**MONTVILLE WATER POLLUTION CONTROL AUTHORITY**  
**WASTEWATER TREATMENT FACILITY HEADWORKS IMPROVEMENTS**

**CONTRACT NO. 2021-5**

**ADDENDUM NO. 1**

#### 3.3 PROTECTION

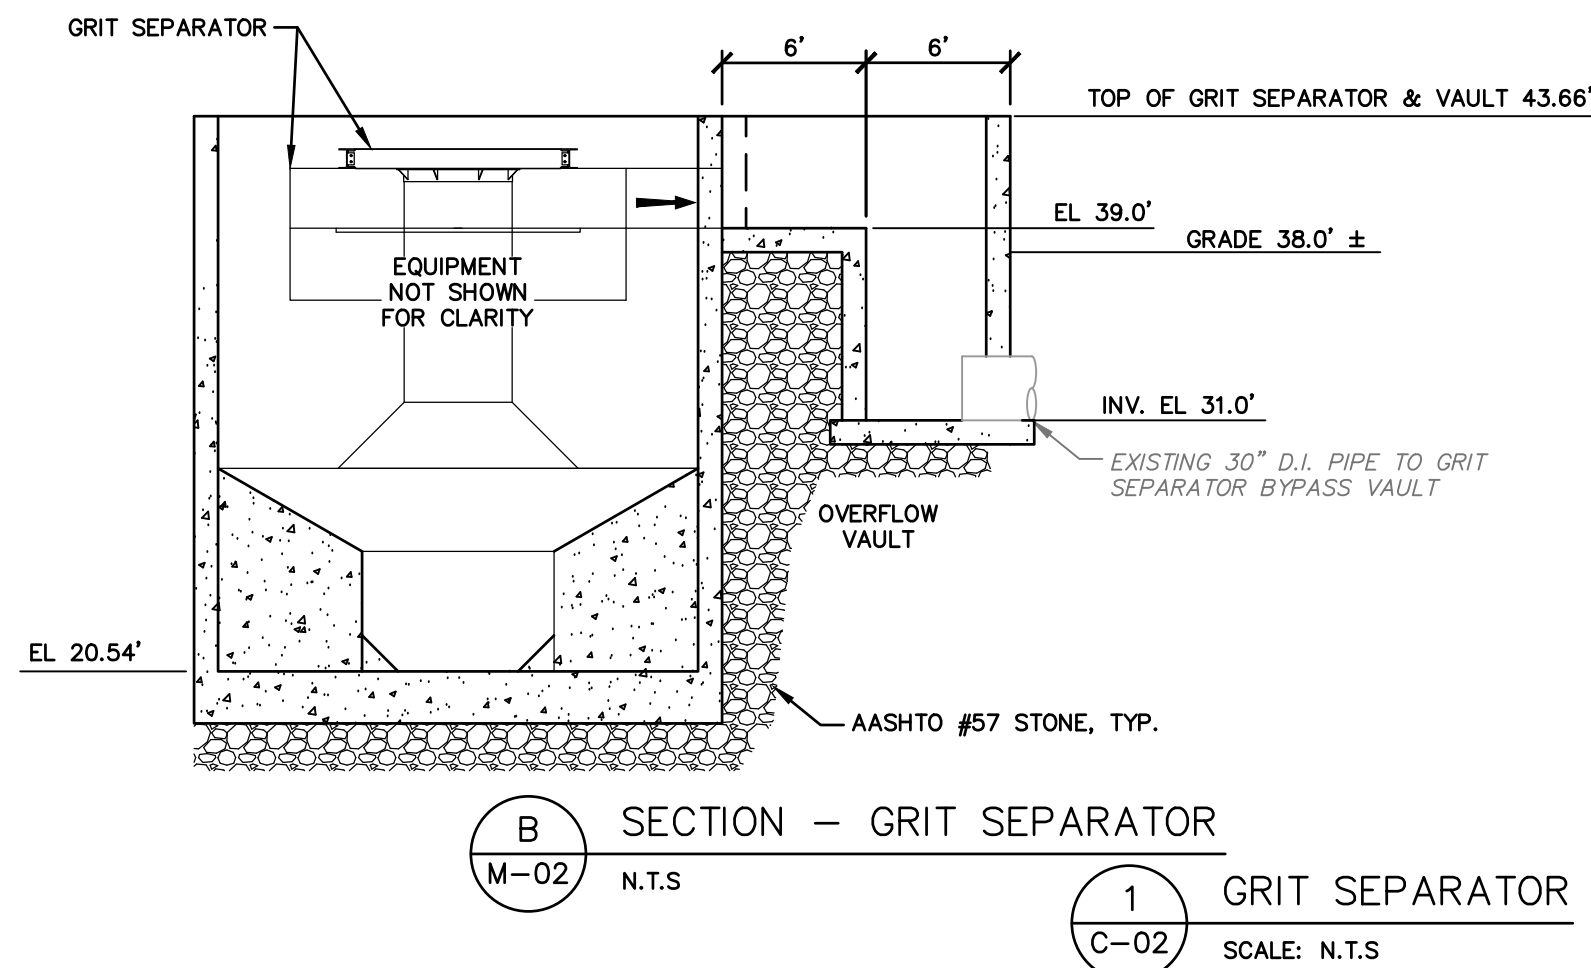
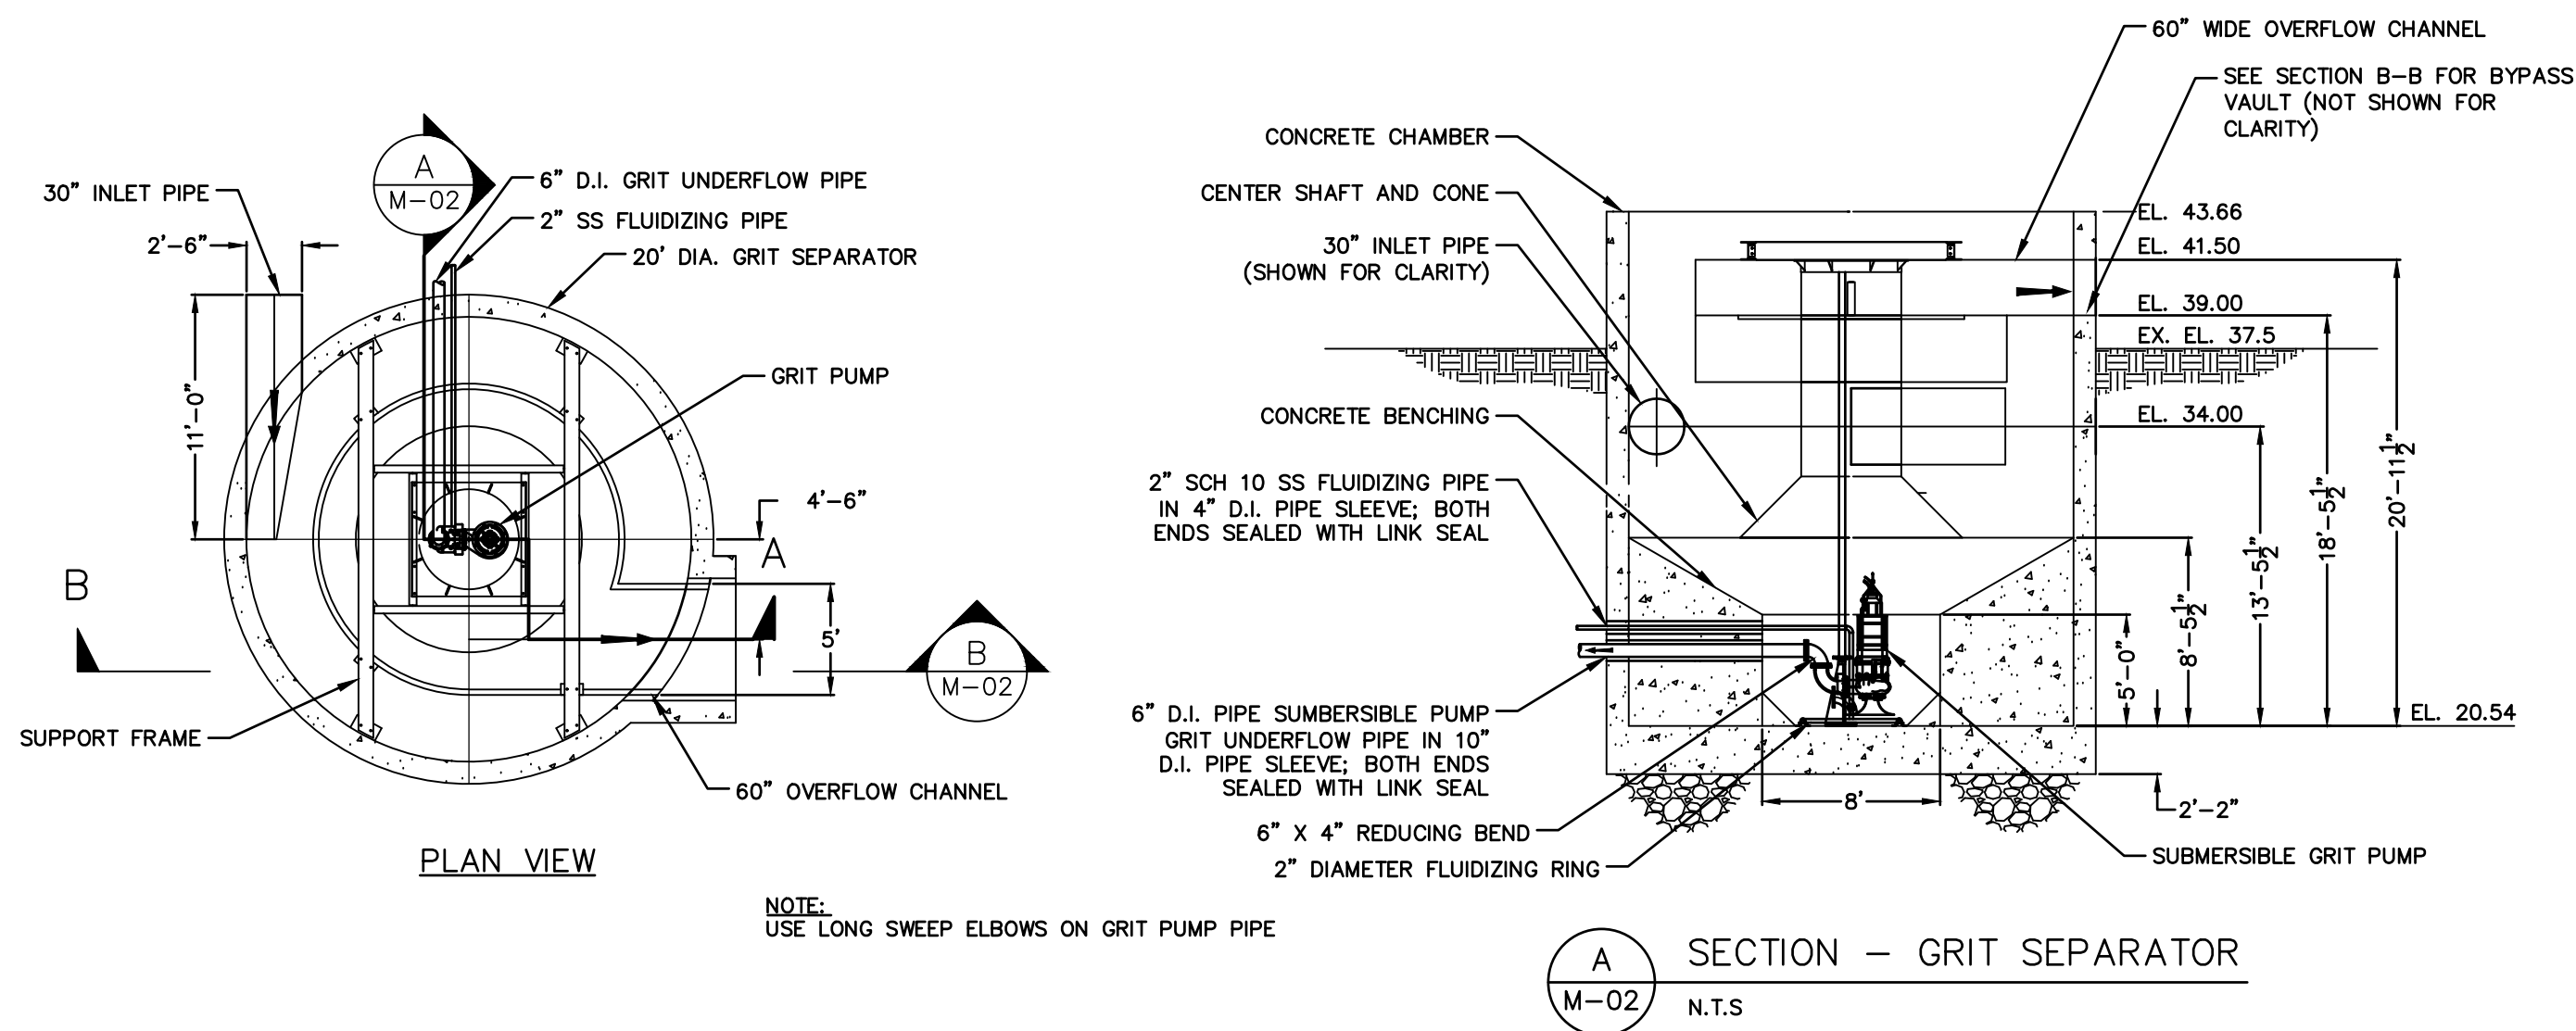
6. **DELETE WITHOUT REPLACEMENT:** Project manual Sections 03400, 'Precast Concrete Structures', Section 03401, 'Precast Concrete Exterior Structures', and Section 04816, 'Concrete Unit Masonry Assemblies'.
7. **ADD:** To project manual, Specification Section 05513. 'Metal Ladders', Attachment 003.
8. **DELETE AND REPLACE:** Drawing M-02 with revision made to Detail 2/C-02 and added detail 3/M-02, Attachment 004.
9. **DELETE AND REPLACE:** Project Manual, Table of Contents, Attachment 005.

2. **Question** - Reviewing sheet S-501 @ Guardrail (13/S-501), please provide the extent of the guardrail? Are there any gates? If so, please provide details and locations.

**Response:** Refer to drawing sheet M-02, Detail 2, Plan View, railing to completely enclose grate platform except at access ladder.
